Complaints And Suggestions from Gulmohar Residency

Project Name : Gulmohar Residency

QUALITY CONTROL CHECK REPORT. Stage: After Plumbing & Electrical (Apartments)

Details of Additions & Alterations

Description	Owners & Developers :	Date :	Promoted by
	Modi Reality Mallapur LLP	23.09.2020	Modi Properties Pvt Ltd
	Project Name & Phase :	Prepared By :	
	Gulmohar Residency	Approved By :	
ELECTRICAL PLAN - 1660 Sq. Ft. -B2 TYPE		Scale :	Phone: +91-40-66335551
			N.T.S

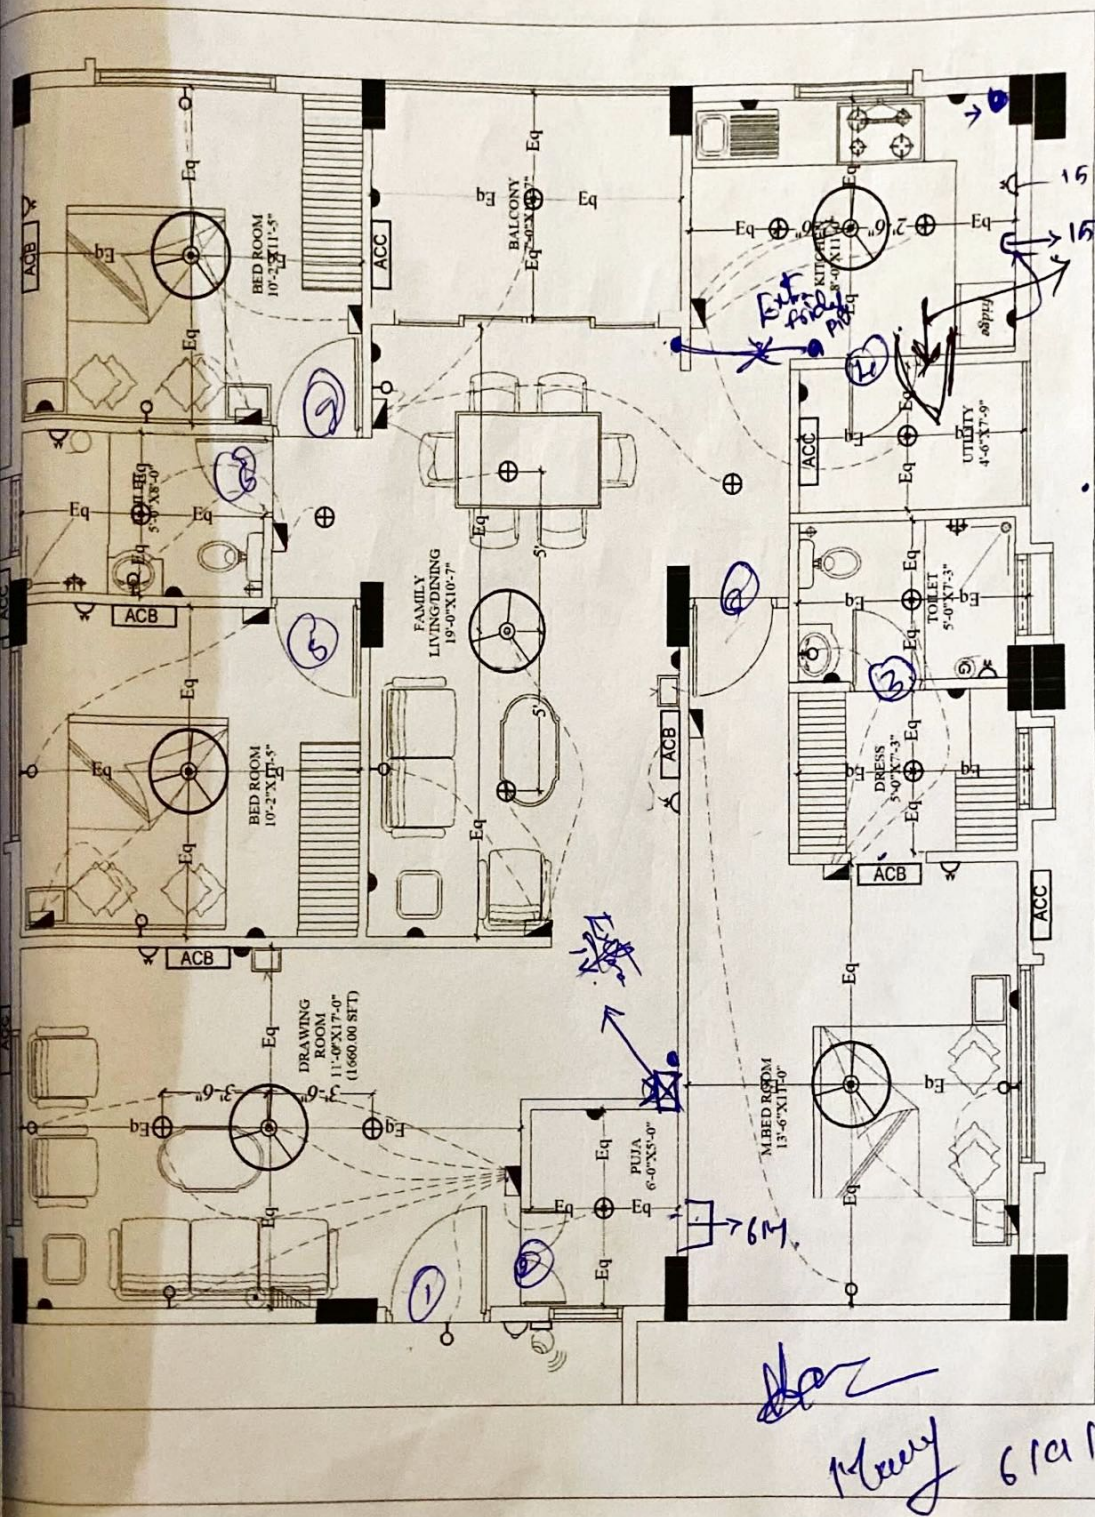
Changes in kitchen platform: (mark on plan)

- ① Modular kitchen by customer.
- ② Rec platform required. 31/5/21

Other Changes:

- ① Pooja frame as mentioned in drawing. size ^{6x2} [6'x5']
- ② M.B door, dressing entrance & size should be change as mentioned in drawing. (immediately)
- ③ Balcony wall should be extended 1'
- ④ Entry door space require in c.T as mentioned in drawing
- ⑤ Entry tap point in utility wash basin point as mentioned in drawing
